RE: Water Well

Re: Site Plan_8180 Stabean Drive

RE: B19002799_8180 Dabean Drive_20x30 Sunroom and Deck

RE: waiver request B19002799

HOUSE LOCATION DRAWING

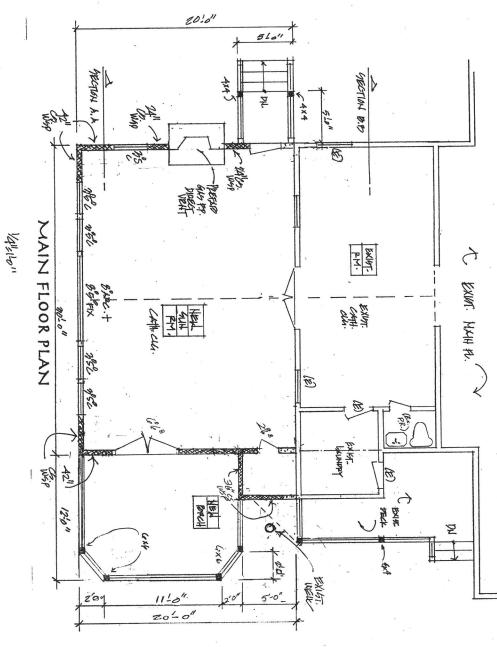
The new site plan is not 1:30 scale. It appears to be 1:60. Is the angular portion of the existing deck closest to the well going away?

Today, I reviewed the waiver request with the Deputy Director of Environmental Health, Mike Davis. In short, he isn't opposed to the waiver request, but he would like the site plan revised to scale (1:30 to 1:100) and reflect the existing house/deck foot print more accurately. Perhaps when the plan is brought up to scale, everything will align but for now the house and deck dimensions don't seem to line up.

Yes, the angled section of the deck is going to be removed. Yes, we are expecting the well drillers letter and will forward it to you. I didn't expect the plan to get to you so quick. Not complaining though!

ADDITION & PORCH

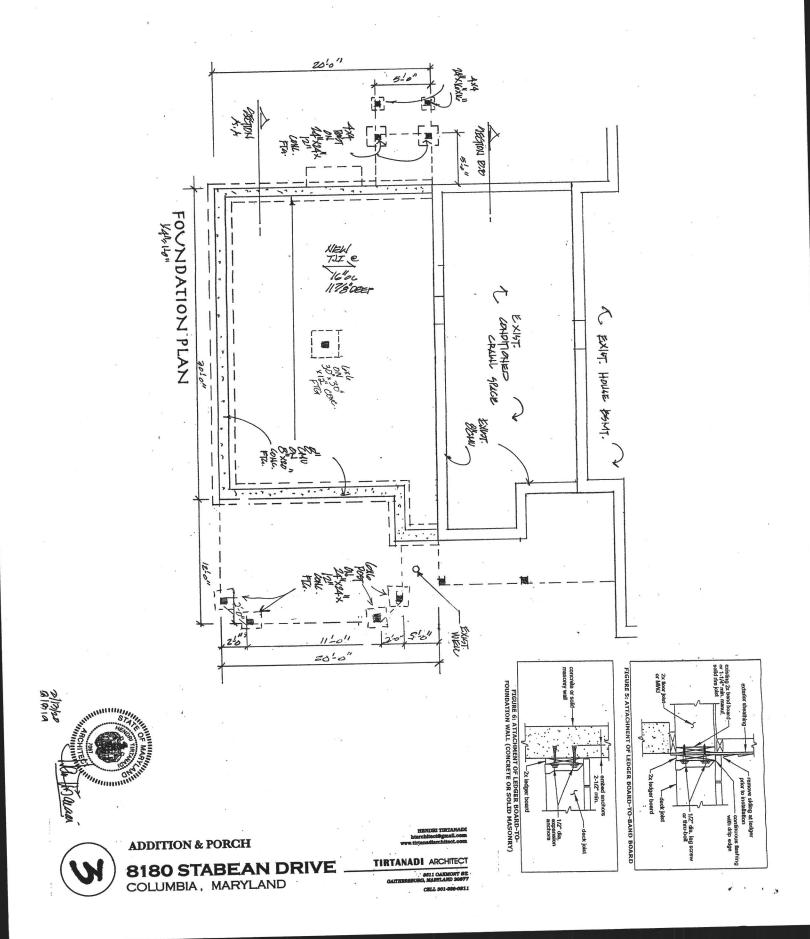
Is a powder room still being proposed within the smaller room of the proposed addition closest to the existing well? Anyway, it looks like the new foundation is getting a little closer than the existing house

corner. If that's the case, you will need to make a variance request even if it's only a few feet closer (see attached variance application to reduce well to new foundation setback). You will need to complete the application and turn in the latest building permit site plan and floor plans to Mike Davis, Assistant Director. Let me know if you have any questions.

Yes, you can avoid the variance process if you pull back the foundation, but we would like confirmation from a well driller that routine maintenance can still be done on the well (i.e. replacing the pump etc.). Let me know if you have any questions.

Could we avoid the variance process if we pull the foundation back away from the well, but keep the building walls where they are? We can cantilever the floor of the closet two feet or more from the well. That should put the foundation equal or further from the well than the existing house.

Site Visit – 12/11/19 8180 Stabean Drive Fulton, MD Well brought above grade.

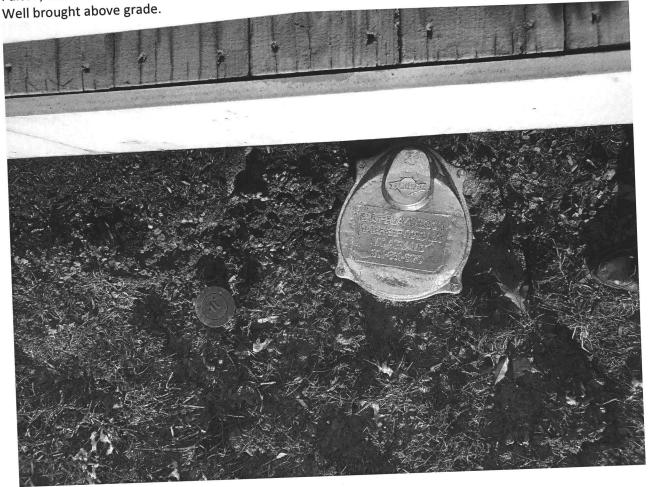
In addition, the well must be brought above grade to meet current code. You may contact a well driller to have this work done (see attached list of well drillers)
